APPLICATION NO.	FILING DATE	FIRST NAMED INVENTOR	ATTORNEY DOCKET NO.	CONFIRMATION NO.
10/807,592	03/24/2004	Gregory C. Franke	200314727-1	3635
22879	7590	05/30/2006	EXAMINER	
HEWLETT PACKARD COMPANY P O BOX 272400, 3404 E. HARMONY ROAD INTELLECTUAL PROPERTY ADMINISTRATION FORT COLLINS, CO 80527-2400			MITCHELL, KATHERINE W	
			ART UNIT	PAPER NUMBER
			3677

<b>Advisory Action</b> <b>Before the Filing of an Appeal Brief</b>	<b>Application No.</b> 10/807,592	<b>Applicant(s)</b> FRANKE ET AL.	
	<b>Examiner</b> Katherine W. Mitchell	<b>Art Unit</b> 3677

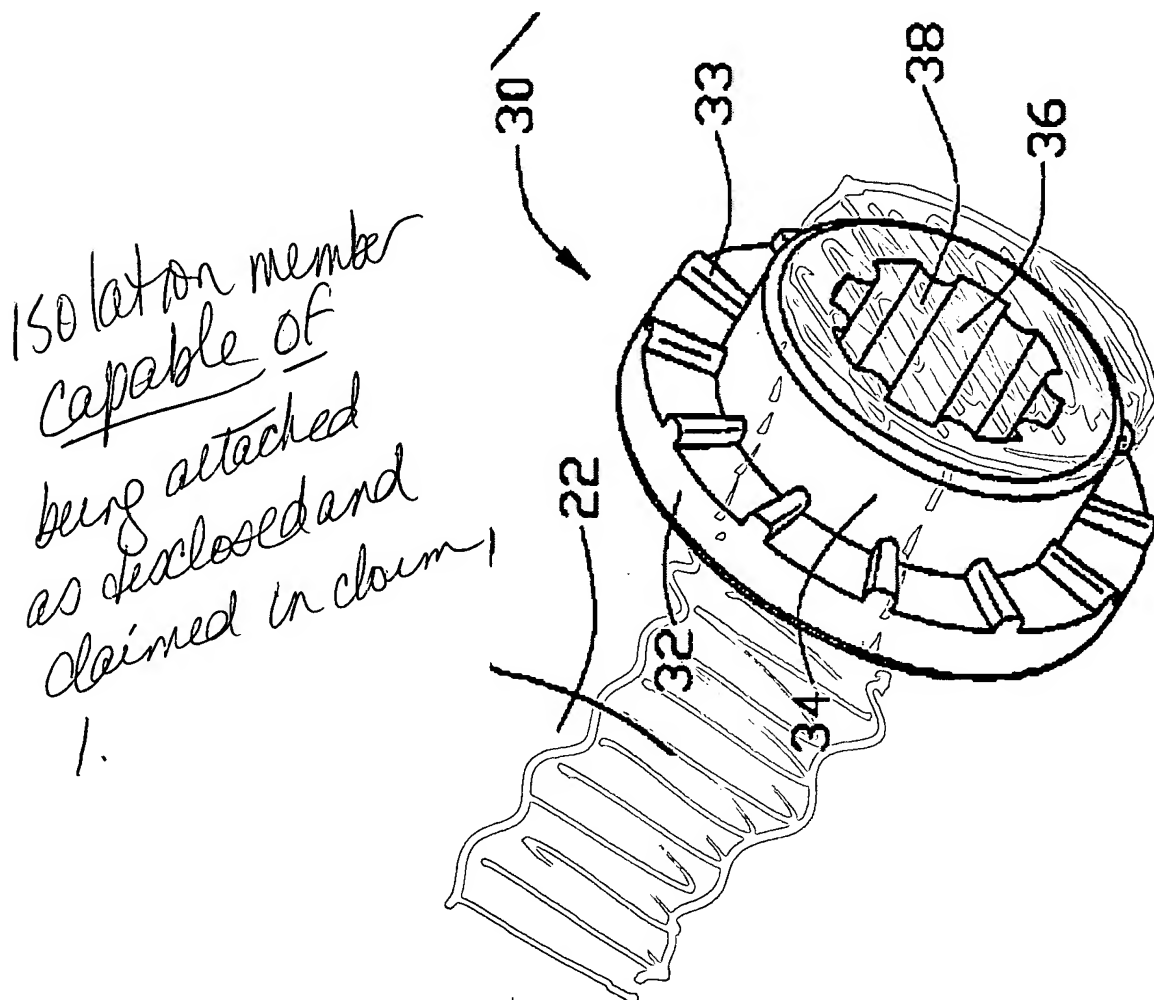
**Continuation of 11:** Claim 1 does not include all the required limitations of claim 20, see below.

**Continuation of 3: NOTE:** Claim 20 was noted as allowable in that it included all the limitations of claim 19, which positively recites and requires a storage media drive with an outer housing that defines the end of the drive, and fasteners that ARE, not could be, mounted to the ends of the drive. This further limits what the drive cage and drive cage slot can be, as the drive housing must correlate to the drive itself. As noted in the previous action, claim 1 is specifically worded to claim only a fastener comprising an isolation member -- no structure of the drive, drive cage, fastener other than isolation member, are claimed or required. Note in particular Lin Fig 1 - isolation member 30 is CAPABLE of having a threaded shank with a head inserted as drawn below:

Similar drawings are possible for Antoine and Sihon - and applicant has not required the other structure, only the ability to allow such structure. The April 2006 office action clarified:
